**PARTS PE EVALUATION REPORT**

SUPPLIER HST2  
PART NUMBER KD04638-E130

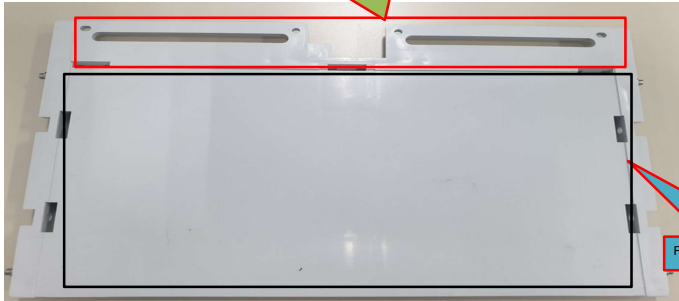
FLATNESS 0.5

Inspection Data	
Sample No.	Data
1	1.48
2	1.33
3	1.1

Flatness was measured on red portion

REQUEST

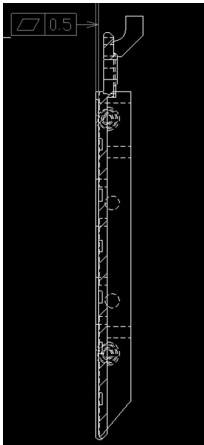
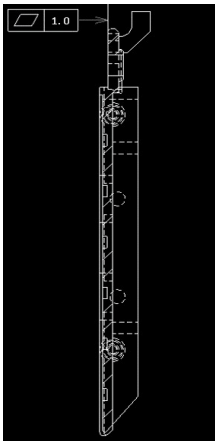
Hisnei Request: Change flatness value to 1mm and flatness will be mesaured on red portion only

- Request is to change flatness value to 1mm and flatness will be mesaured on red portion only
- Flatness is hard to control due product has warping
- This is same as KD03415-E200

Inspection Data on Red aae:  
0.50  
0.55  
0.60
